Company: Eugene School District 4J
Project: **Multisite Decommission Oil Tanks 2015**
C.I.P. 420.780.020

Subject: Addendum #1

**TWIN OAKS
ELEMENTARY SCHOOL**

DATE: 04/07/15
**TANK
REMOVAL PLAN**
SHEET:
8.1r OF 17

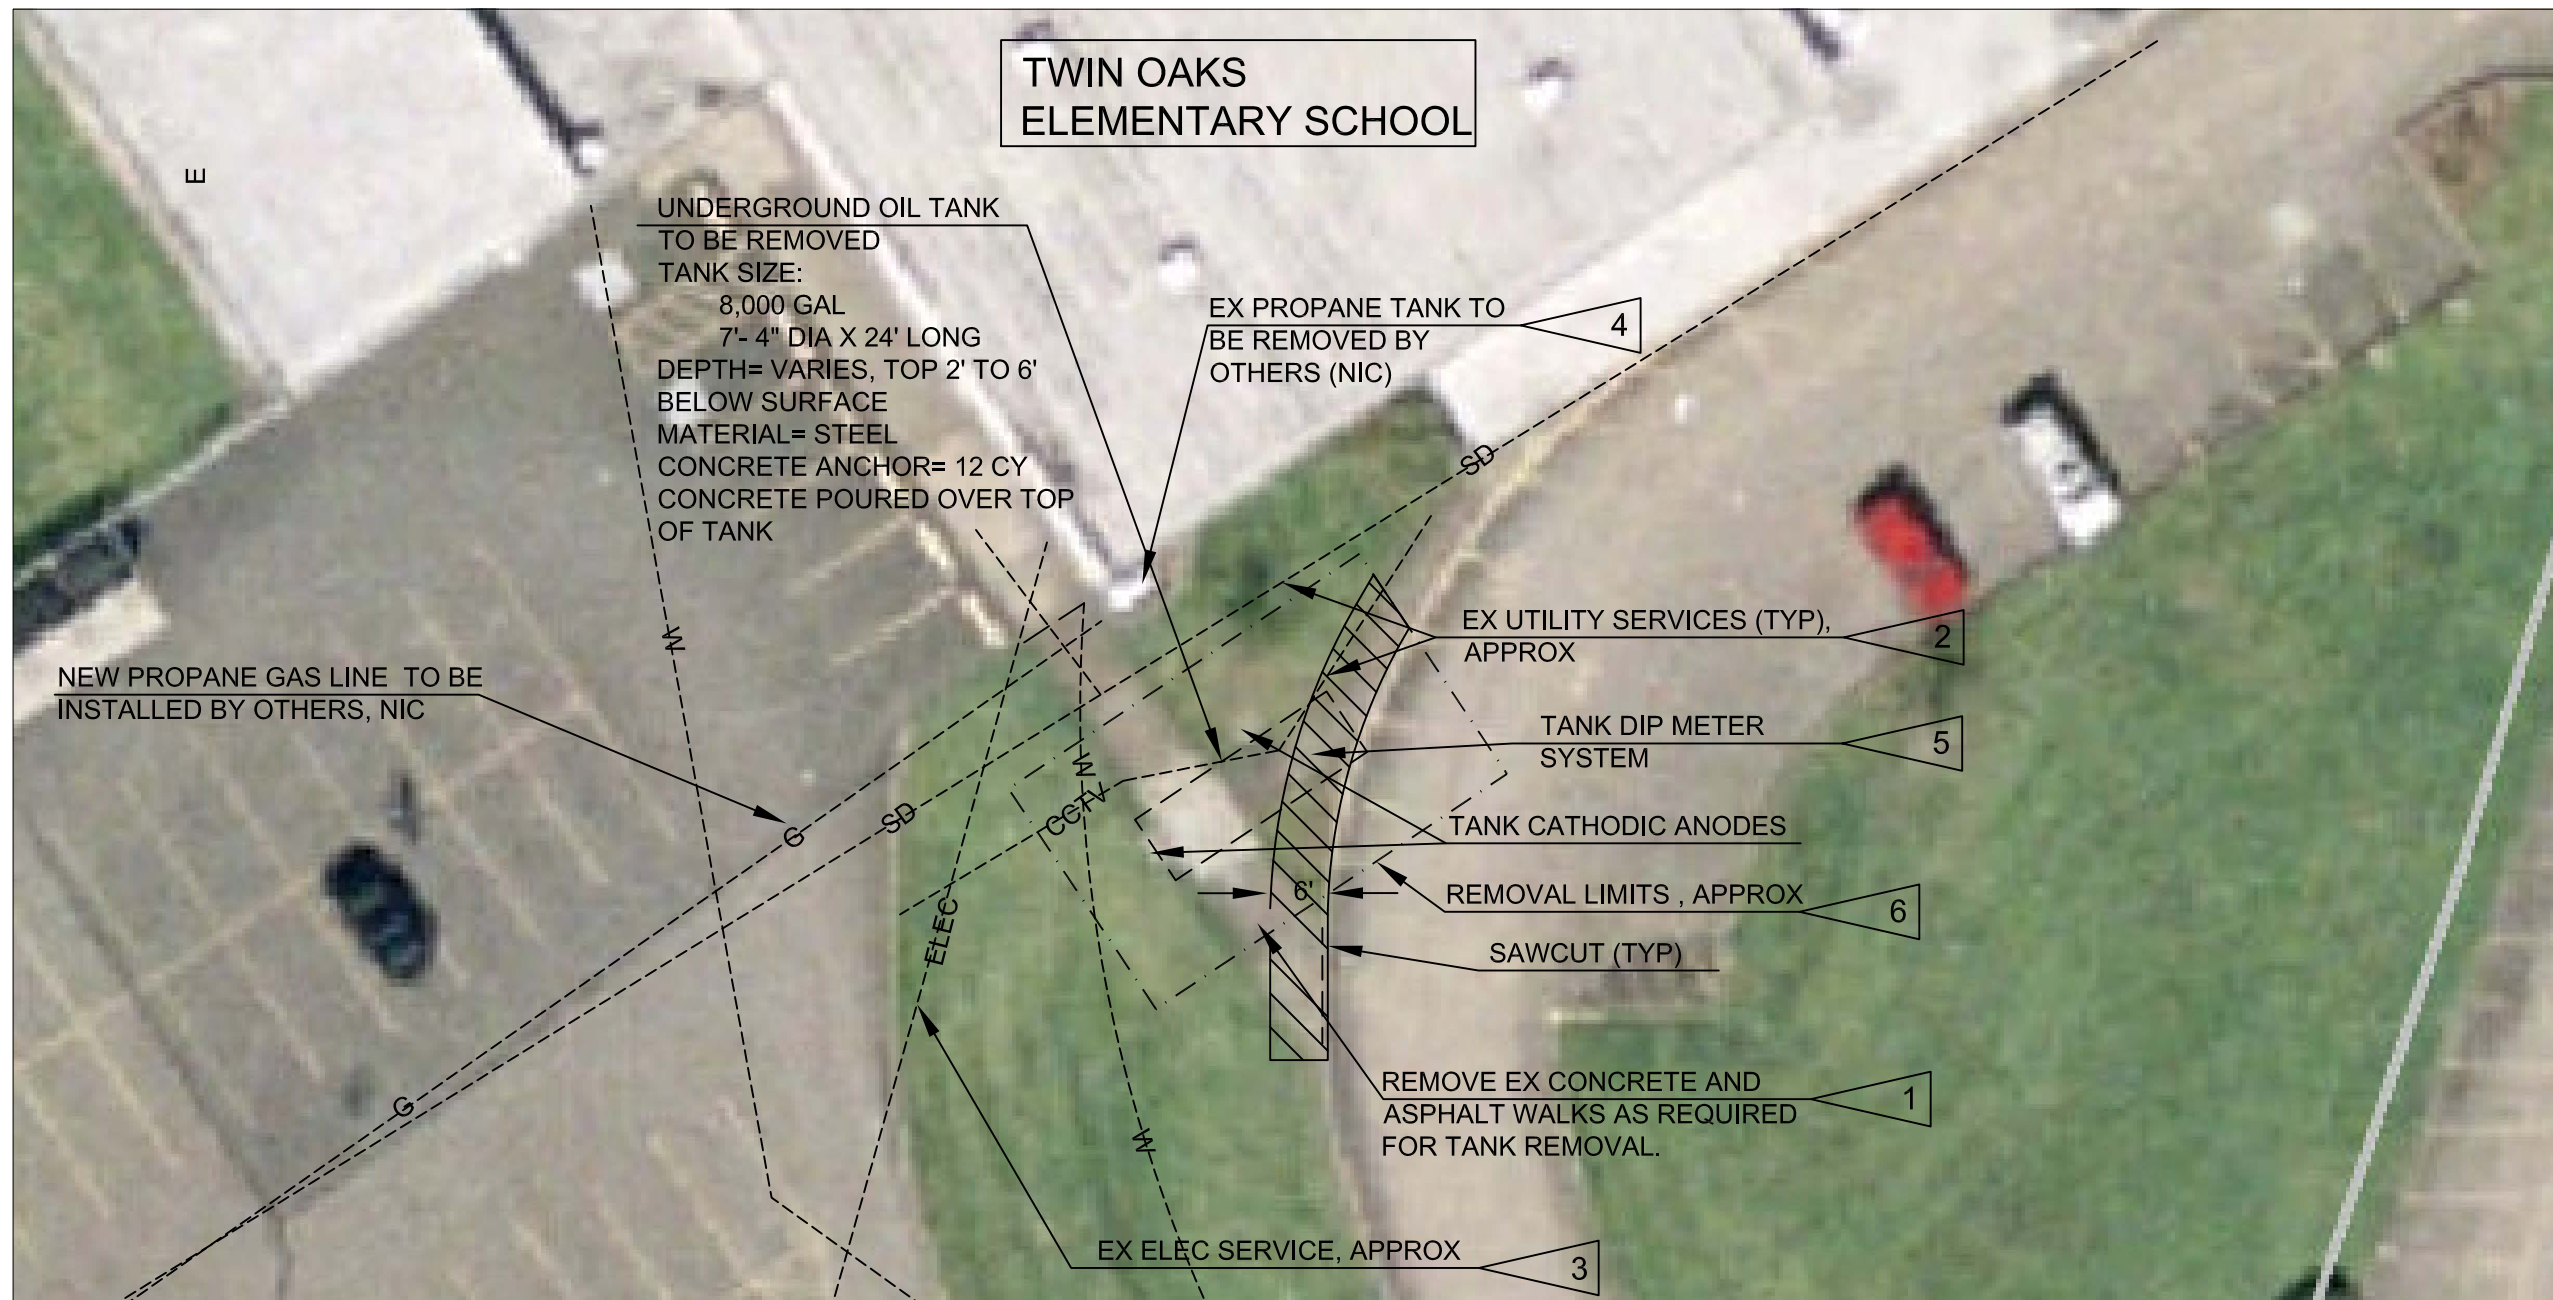
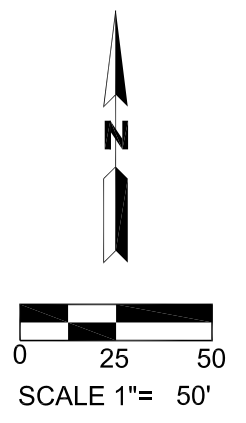
2. Drawing Sheet 8.0 and 8.1, Twin Oaks ES:

Replace sheets 8.0 and 8.1 with 8.0r and 8.1r.
